Airworthiness Directive: #113

Subject: 2-3 Longeron/Main Gear Brace Attach Point

Model Effected: S-4 Coyote I (Taildraggers)

MD2531

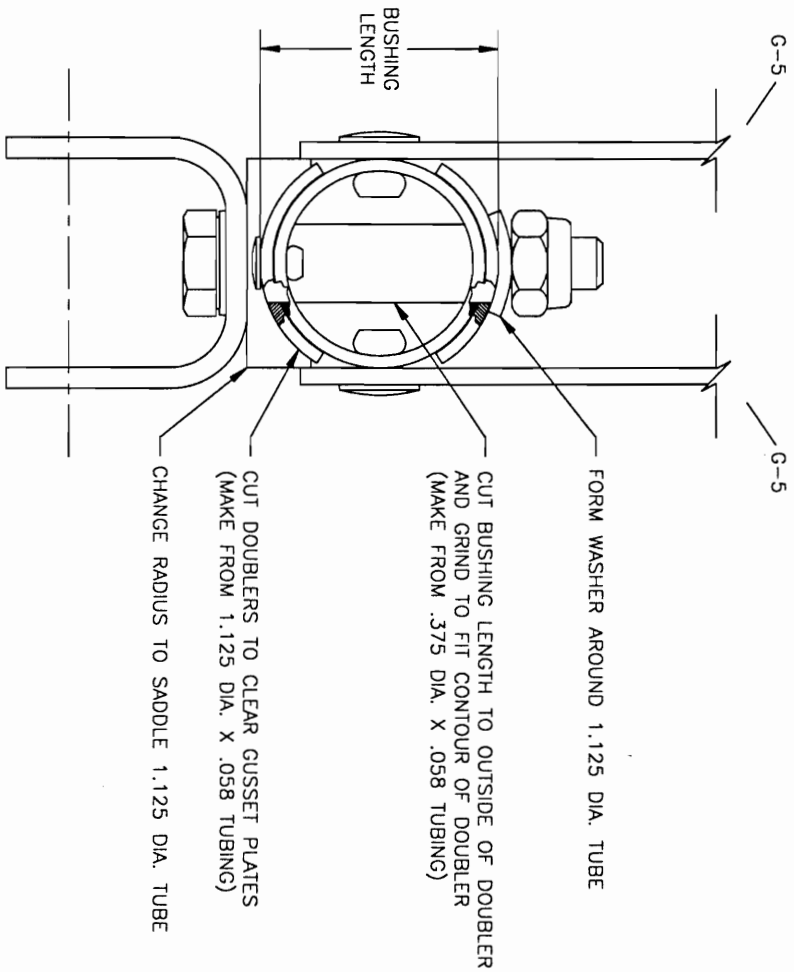
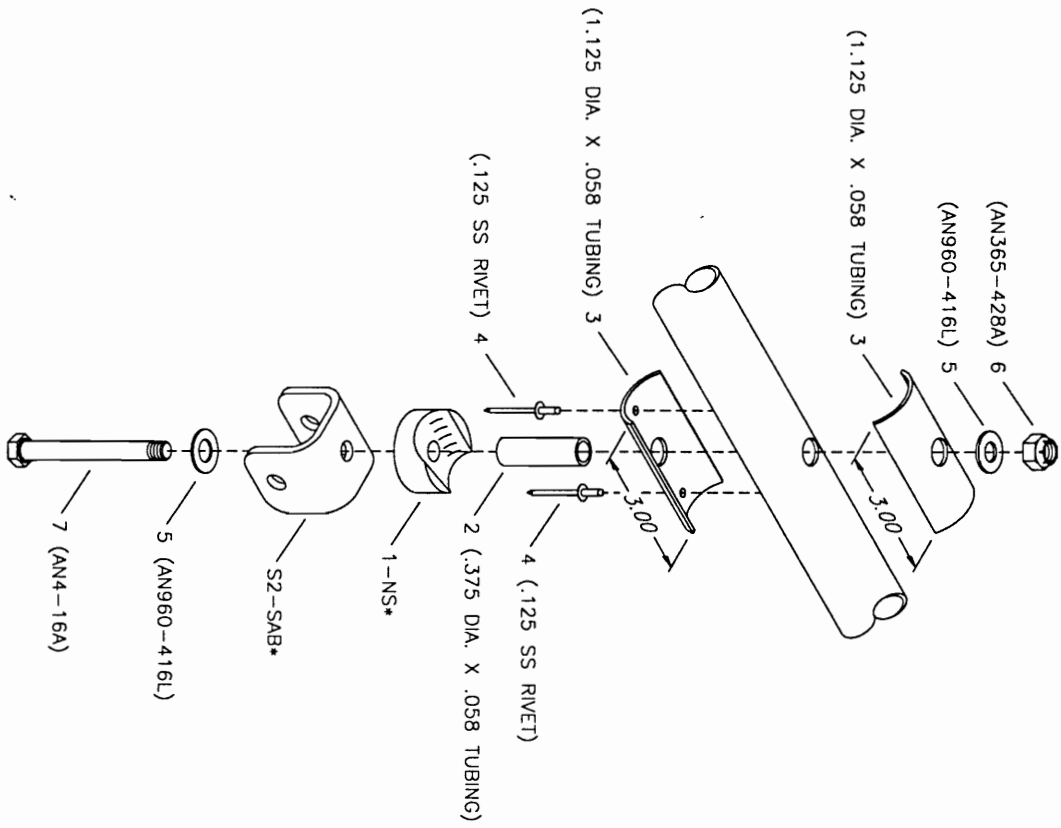
The attachment point between the main gear brace and longeron (part # 2-3) connecting stations 2 and 3 on the S-4 is designed with an internal doubler. On some aircraft this doubler is missing. Without this doubler installed, the main gear brace attachment bolt could pull through the longeron. To correct this problem, one must first determine if the doubler in question is missing. Do so by supporting the aircraft by the struts where they attach to the wing. Hint: Two sturdy step ladders can be used. Remove the bolt retaining the aft gear brace to the longeron and inspect for the doubler. If the doubler is missing, please follow the recommended fix per the illustration below.

Note: The parts in the illustration can be ordered from the parts department. Ask for kit No: AD#113.

NO.	DESCRIPTION	MATERIAL/PART	QTY.
1	ILLUSTRATION	MD2531	1
2	BUSHING	.375 DIA. X .058 X 1.13	2
3	DOUBLER	1.125 DIA. X .058 X 3.00	2
4	SS RIVET	CCPQ-42	4
5	WASHER	AN960-416L	4
6	NUT	AN365-428A	2
7	BOLT	AN4-16A	2
